S2S Cycle & Footway Interim Works Bull Road to Causeway Road

Stage 3 Road Safety Audit

August 2017

2.2.5 Problem (S5) Carriageway Surface at Crossing on Bull Road

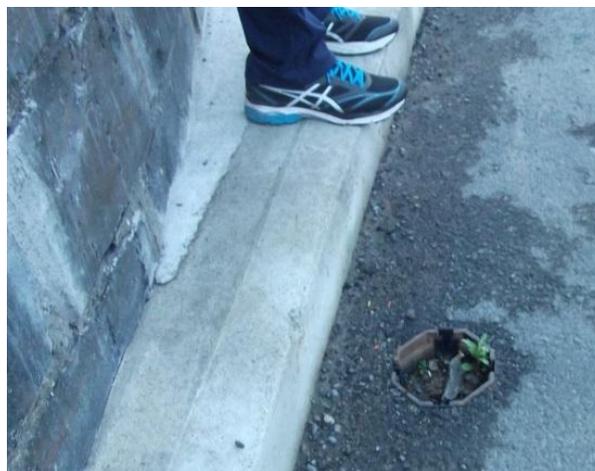
The existing carriageway surface at the crossing presents a trip hazard and an uneven surface for both pedestrians and cyclists. Additionally grit/loose gravel on the carriageway may result in vehicles skidding leading to loss of control incidents.

It is recommended the carriageway is finished to an appropriate standard to ensure an even surface for pedestrians/cyclists/vehicles.

2.2.20 Problem (S20) Bus Stop South of Dollymount Park

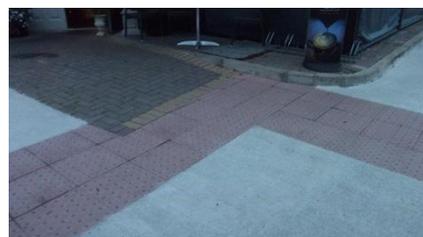
The auditors are concerned that when northbound buses are stopped at the bus stop (as located to the south of Dollymount Park), forward sight visibility to the new pedestrian crossing (and associated signal heads) may be restricted for northbound vehicle drivers. Failure to provide adequate forward sight visibility to the pedestrian crossing may result in vehicle drivers failing to observe a pedestrian utilising the crossing, and/or vehicle drivers may not be given insufficient time to reduce their speed, both of which increases the potential for conflict between a vehicle and a pedestrian.
